ECE/TRANS/WP.29/GRRF/59/Add.1
1 March 2006

**REPORT OF THE WORKING PARTY ON BRAKES AND RUNNING GEAR (GRRF)
ON ITS FIFTY-NINTH SESSION**

DRAFT 01 SERIES OF AMENDMENTS TO REGULATION No. 117 (Tyre rolling sound)
(This text was adopted by GRRF at its fifty-ninth session, see para. 22).

Example 2

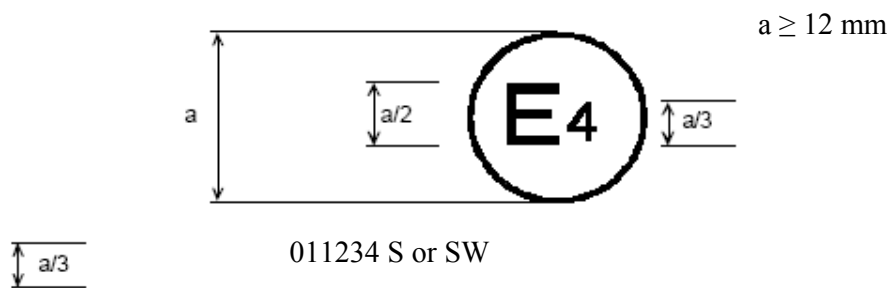
The above approval mark shows that the tyre concerned has been approved in the Netherlands (E4) pursuant to Regulation No. 117 (marked by S (rolling sound) or both S (rolling sound) and W (wet adhesion), under approval number 011234. This indicates that the approval is for S or both SW. The first two digits of the approval number (01) indicate that the approval was granted according to the 01 series of amendments.

Example 2

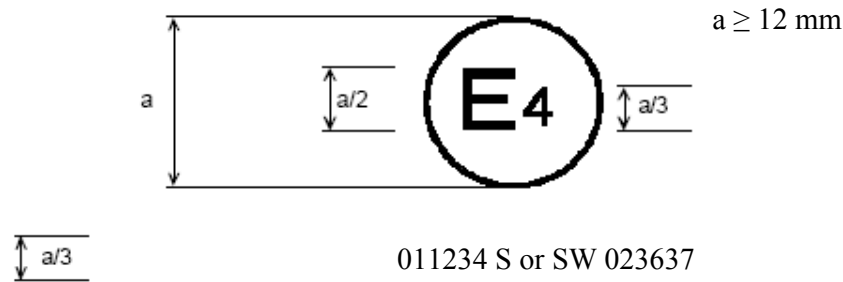
The above approval mark shows that the tyre concerned has been approved in the Netherlands (E4 pursuant to Regulation No. 117 (marked by S (rolling sound) or SW (rolling sound and wet adhesion)), under approval number 011234 and Regulation No. 30 under approval number 023637. The first two digits of the approval number (01) indicate that the approval was granted according to the 01 series of amendments, but Regulation No. 30 included the 02 series of amendments.

Example 2

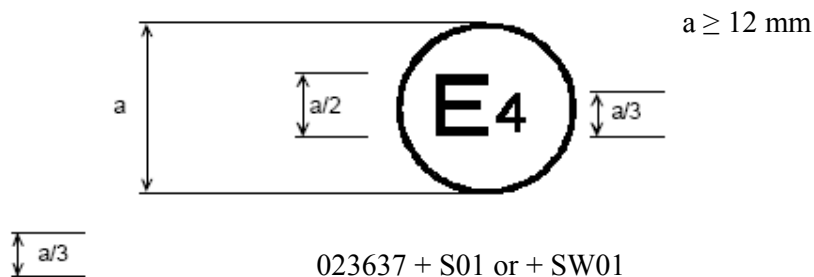
The above approval mark shows that the tyre concerned has been initially approved in the Netherlands (E4) pursuant to Regulation No. 30 and the 02 series of amendments under approval number 023637. This indicates that the approval is for S (rolling sound) or S (rolling sound) and W (wet adhesion). The S or SW followed by (01) indicates that it has had its approval extended under Regulation No. 117 which included the 01 series of amendments. The first two digits of the approval number (02) indicate that the approval was granted according to Regulation No. 30 which included the 02 series of amendments. The addition (+) sign indicates that the first approval was granted in accordance with Regulation No. 30 and has been extended to include Regulation No. 117 approval(s)."
